# Critiqued Answer Script

**Question 2 – February 2023 Chartered Membership Exam**  
Author: Jon Bird

## Q2. Office Building

Structural Depths

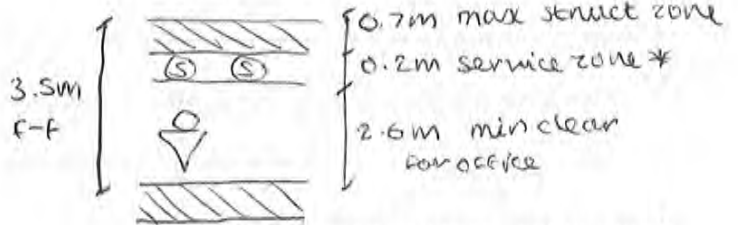
The use of sketches here is an effective way of showing your thought process to the examiners. Contaminated land recognised as an issue and discussed.

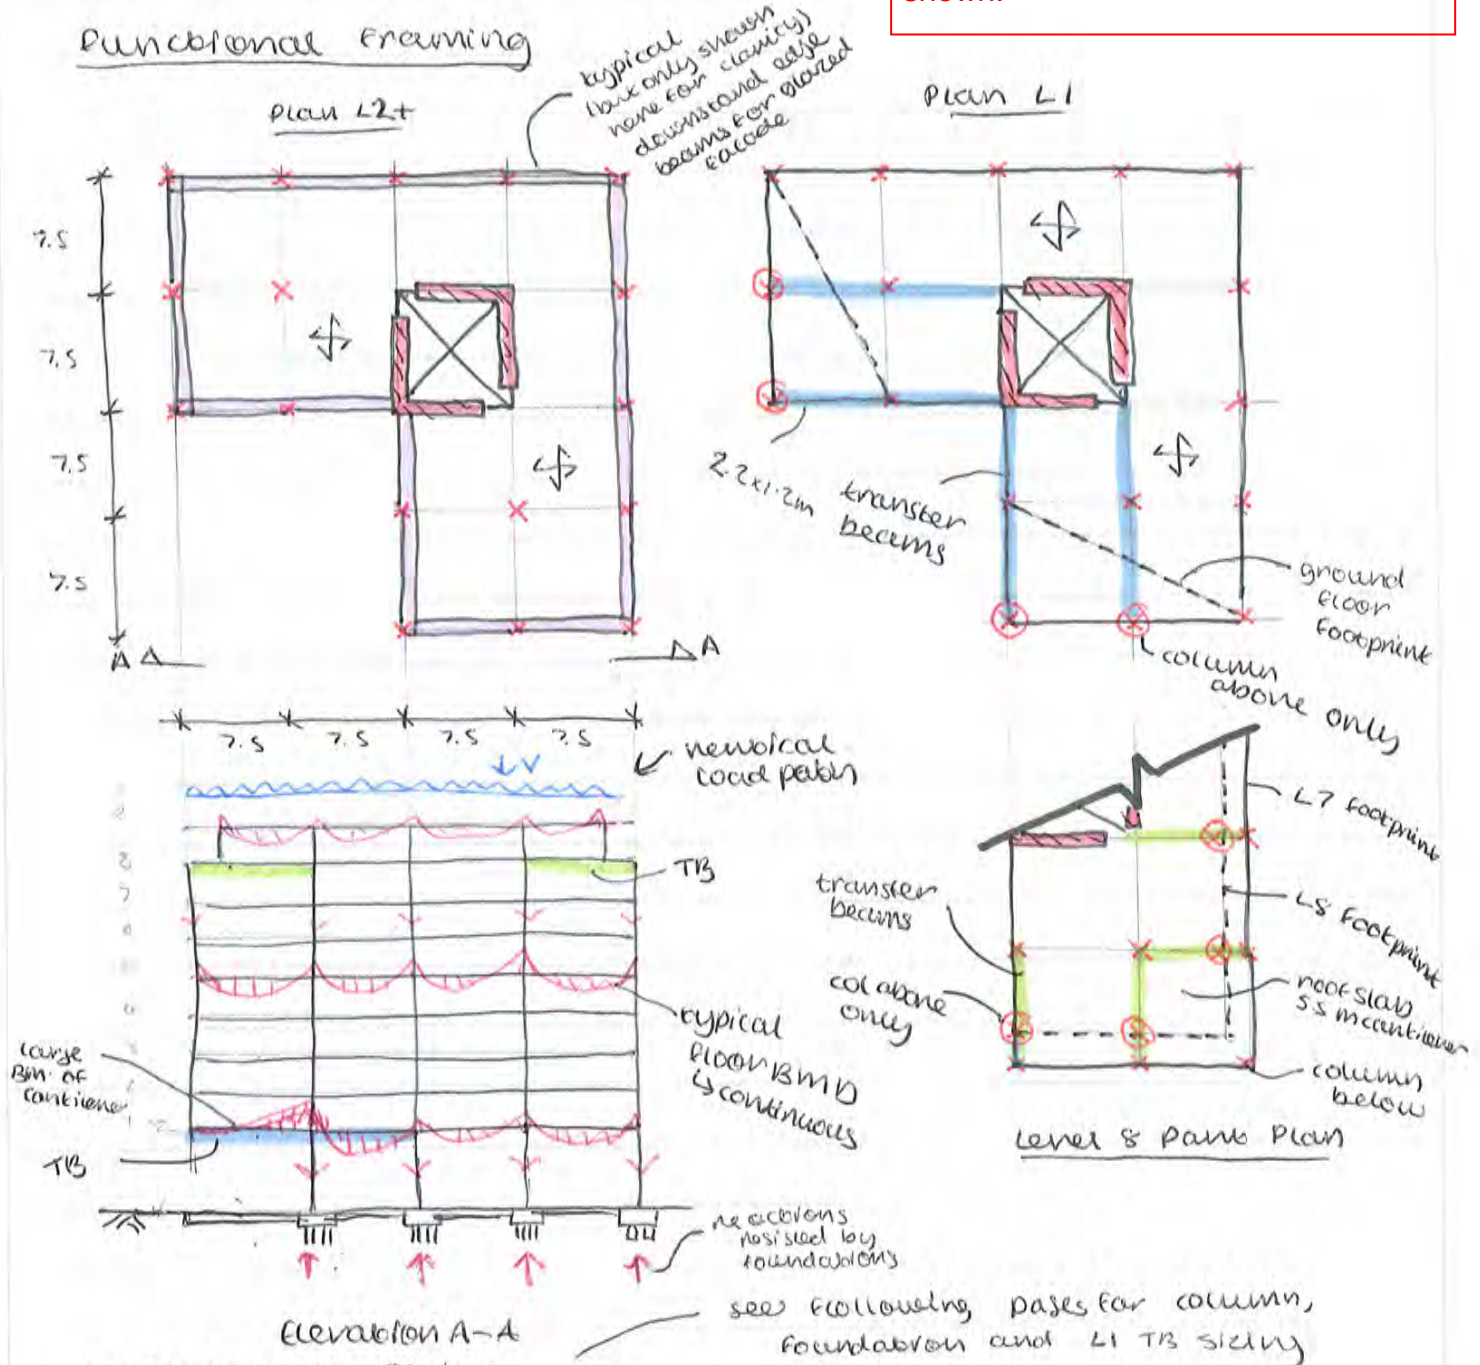
Effective and clear sketches. Use of colour and key helps to keep sketches clear and simple to understand. Key transfer structures shown.

Level 1 Transfer Beam → Try 2.2m deep

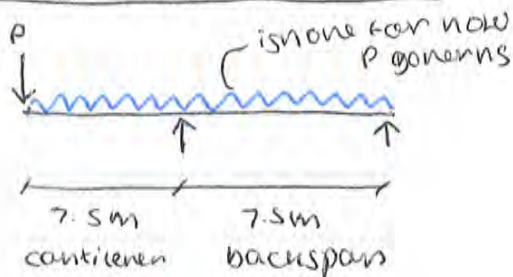
Sizing calculations for key members is important, and candidate has correctly recognised that a span/depth check would not be sufficient for this member.

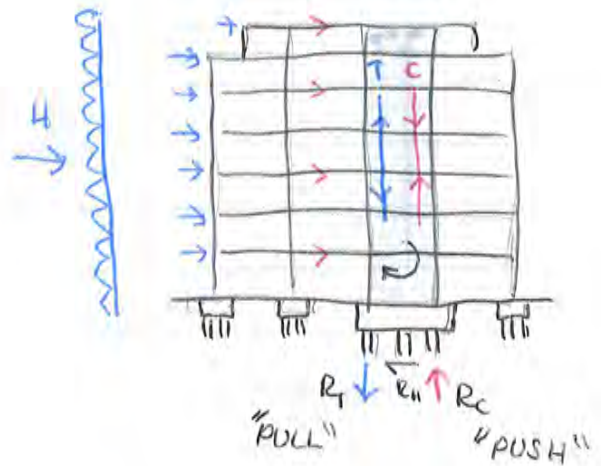
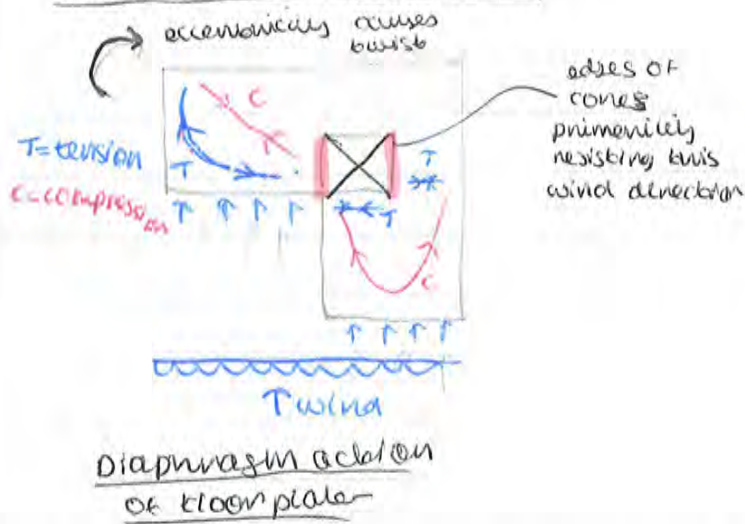
Simple and clear description, referring  
back to a clear sketch

Again the candidate has used a clear and simple description with clear sketches.

Looking at distinctness:

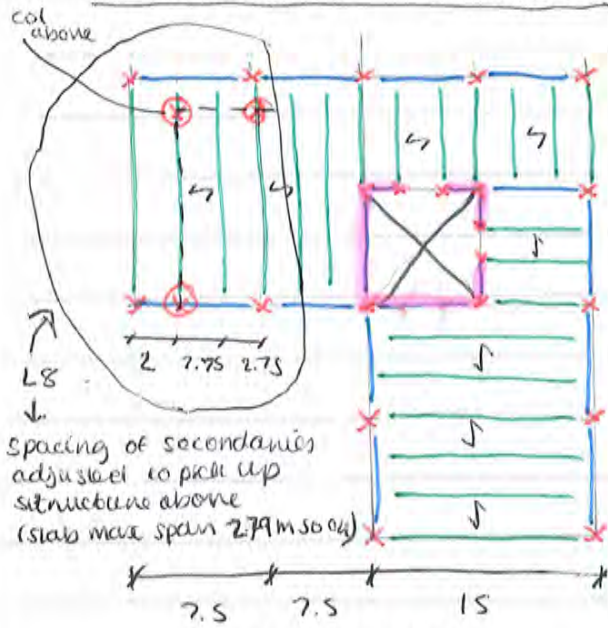
Frame - distinct framing, but could maybe add comments along lines of "clear spans give more flexibility for future use changes".

Could also maybe discuss any alternatives considered for locations of transfer structure.

Foundations - not distinct for the 2 schemes. It is acceptable to have piled solutions to both schemes, as long as alternatives are discussed and ruled out as unviable. This discussion has not been done by this candidate.

Candidate recognised an issue with their scheme on upper floor and dealt with this clearly

Steel Braced Bay

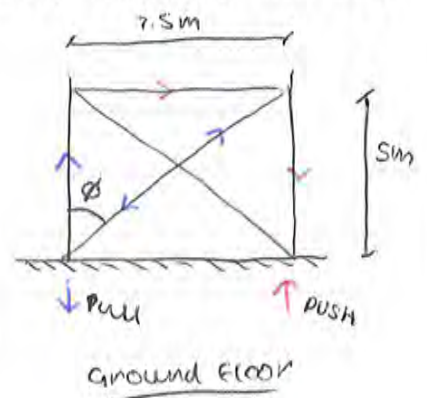
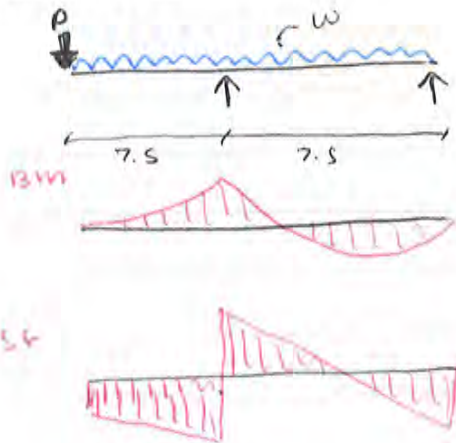
Acceptable, but should consider eccentricity effect to increase forces in braced bay.

**KEY PLAN**

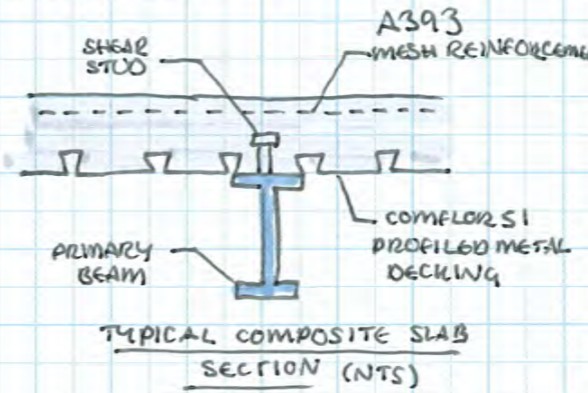
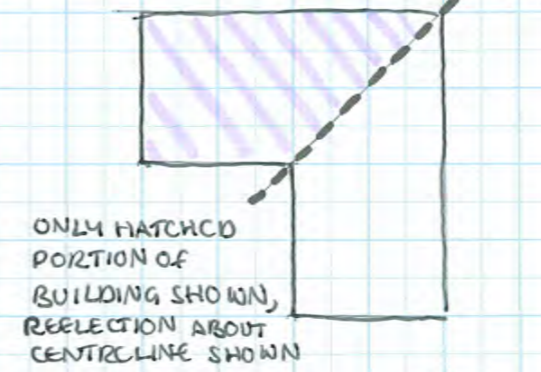
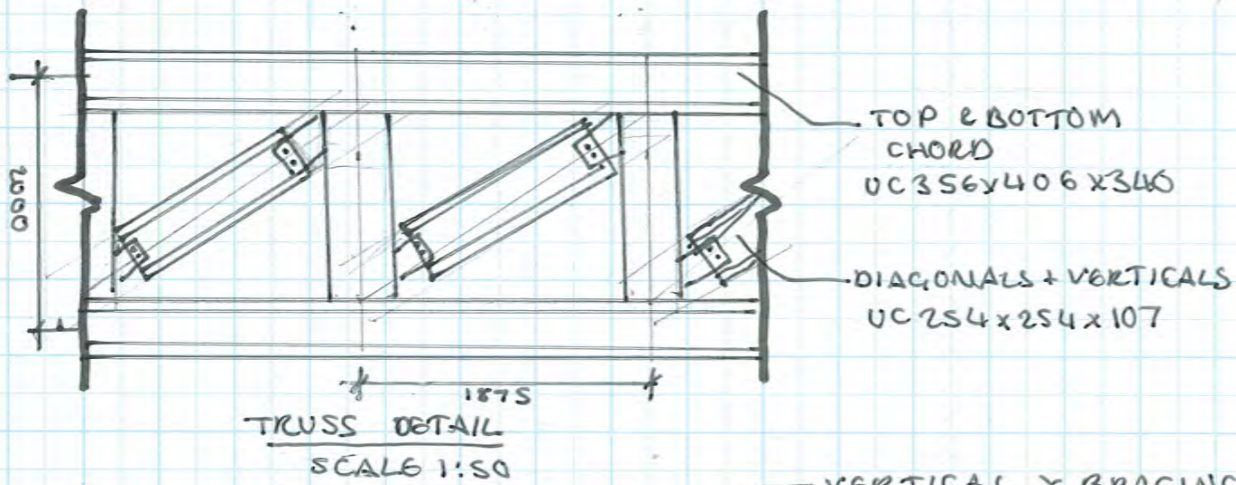
Clear and well thought out drawings.  
Notes clear.
